Brescia, 2nd July 2014

IMPROVEMENT ON PRODUCTS	HERCULES VII 250 t HERCULES VIII 500 t
NEW PART NUMBER	RG00588

NEW PART NUMBER*	RG00588
IN PRODUCTION FROM	June 2014

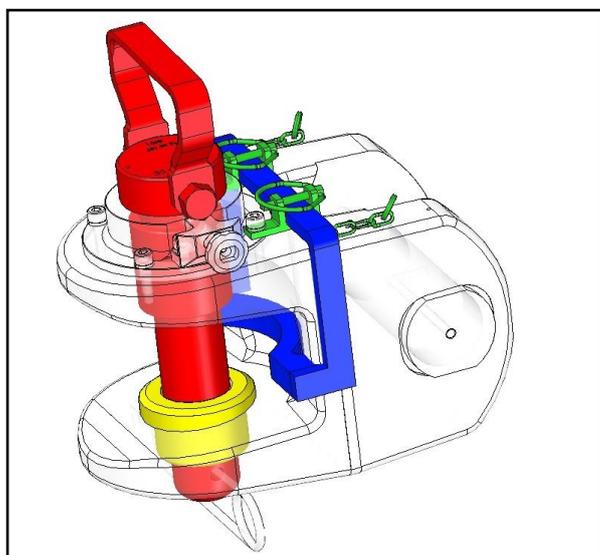
As part of our continuous improvement program, we have released this new part number:

* Please check the below 3D photo

The above new kit RG00588 is now available:

1. It can be retrofitted on any T100210 (Hercules 500 t) to convert it into T100110 (Hercules 250 t); the rating of your T100210 (Hercules 500 t) will be automatically converted into the rating of the T100110 (Hercules 250 t)
2. The kit allowed the operator to increase the performance of the connection using the body of a 500 t Hercules coupling
3. The kit includes all parts showed in the above 3d drawing
4. After installing the conversion kit, a 50mm drawbar eye must be used
